URBAN DESIGN CONSULTATION RESPONSE

Design Officer	Azhar Kapadi
Date	02.05.25
Application Reference	24/01137/FUL
Address	Land At Salley Street,, Calderbrook, Littleborough, OL15 9NG
Proposal	Erection of new residential dwelling

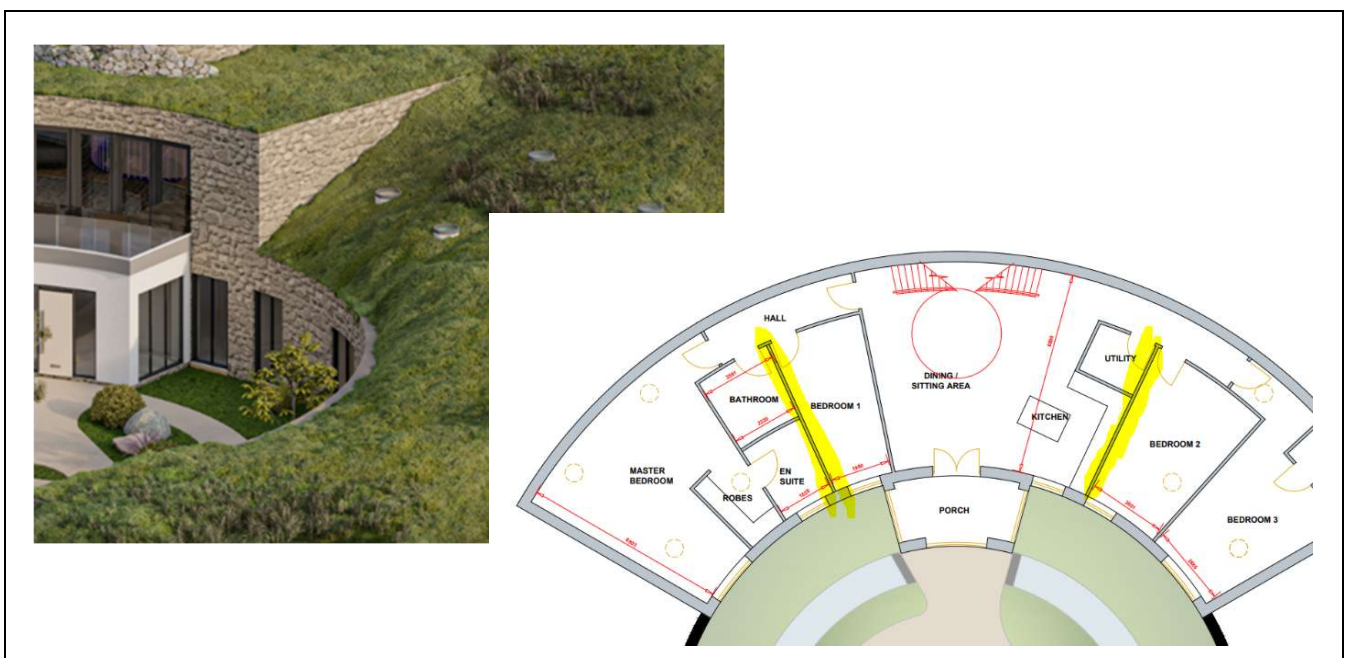
During our site visit, it became clear that the actual topography and appearance of the land differ significantly from what has been depicted in the submission. To accommodate both the proposed building and a ground source heat pump system, it appears that extensive excavation of the entire plot would be required. While the drawings attempt to reflect the site's natural gradients, the transitions between these levels and the building itself risk appearing artificial once constructed.

Several practical and technical questions remain unanswered:

- *How will the green roof in this area be managed to blend seamlessly with the surrounding natural landscape?*
- *What maintenance strategy is in place for this green roof?*
- *How is the land's declivity, as well as that of the roof, proposed to be constructed?*

Constructing such a form will likely require a significant structural solution capable of bearing substantial loads. Based on the current drawing package, there is insufficient evidence to demonstrate the design team's ability to deliver these complex elements effectively. As a result, there is concern that the final outcome may dilute considerably from what has been illustrated, potentially resulting in visual and ecological harm to the Green Belt and the character of the area.
